REMARKS

TSMC97-542/TSMC98-021

VERSION WITH MARKINGS TO SHOW CHANGES MADE

FIG. 2h

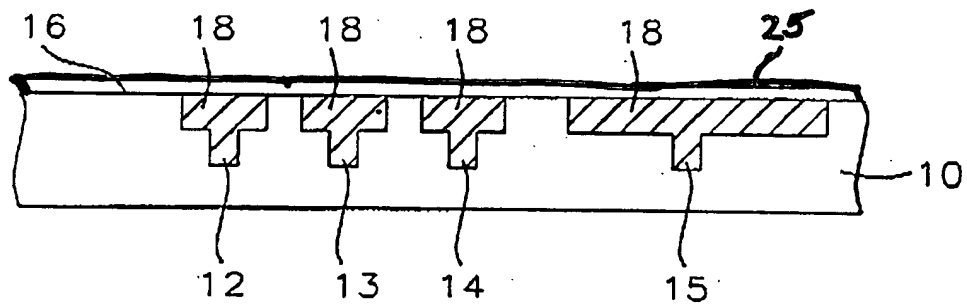
2. The objection to the drawings under 37 CFR 1.83(a) has been addressed by adding the cap layer 25 to figures 2h and 3g and amending the specifications to delete the term “(not shown)” and to add numeral 25 to the cap layer.

In the next step, FIG. 2f, the photoresist is stripped away, exposing the electroplated copper 18. The copper dual damascene 18 and barrier metal layer 16 are next planarized by CMP. FIG. 2g shows the copper partially removed by CMP and FIG. 2h shows the copper dual damascene 18 and metal barrier layer 16 after completion of CMP where the copper dual damascene 18 is completely coplanar with the upper surface and without any dishing in the trenches 12, 13, 14, and 15. In a last step [not shown] the copper dual damascene is sealed with a cap layer 25, such as nitride or oxynitride. The copper layer 18 can be replaced by a layer of metal from the group comprising gold, aluminum, tungsten, titanium, or silver.
